# AP1000 DESIGN CERTIFICATION REVIEW

## Draft Safety Evaluation Report Open Item Response

DSER Open Item Number: 3.7.2.3-2 (Revision 1)

DSER Open Item Number: 3.7.2.9-1 (Revision 1)

Figure 3.7.2.9-1-1: Node 532 – FRS comparison - Y Direction

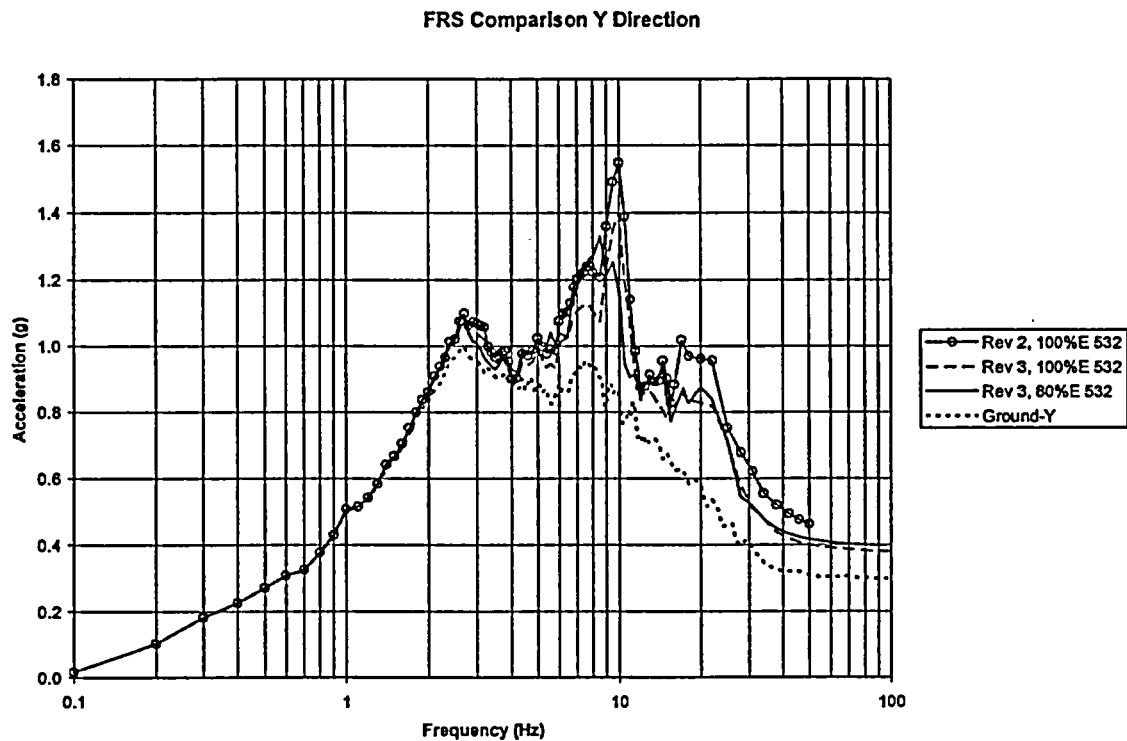
As described in DCD Tier 2 Section 3.7.2.9, as part of accounting for parameter uncertainty, Westinghouse in its response to DSER Open Item 3.7.2.3-1 shows floor response spectra which include the effects of stiffness reduction due to shear wall concrete cracking. In comparing the floor response spectra published in DCD Revision 3 which was based on uncracked concrete properties (100% E), and DCD Revision 6 which is based on partially cracked concrete properties (80% E), it is found that in most instances the 80% E analysis, shows increases in floor response spectra peaks. There are a few instances however where the floor spectra peaks have been reduced. Examples of this are the floor response spectra in the EW (Y) direction of the containment internal structures nodes 532 and 535. The staff would like Westinghouse to cite the reasons that can explain the change in the reduction at these two locations.

Figures 3.7.2.9-1-1 and 3.7.2.9-1-2 show the floor response spectra in the EW (Y) direction of the containment internal structures nodes 532 and 535. The differences between the Rev 2 100% E spectra and the Rev 3 100 %E spectra are due to a more accurate representation of the nuclear island model (including the SCV being attached to the CIS). This more accurate representation included smaller masses at these locations as well as new beam properties based on the CIS finite element model stiffness analyses. The differences between the Rev 3 100% E spectra and the Rev 3 80 %E spectra are due to change from uncracked to partially cracked concrete properties. The reduced stiffness changes cause slight changes in the nuclear island mode shapes that reduce the response in this location.
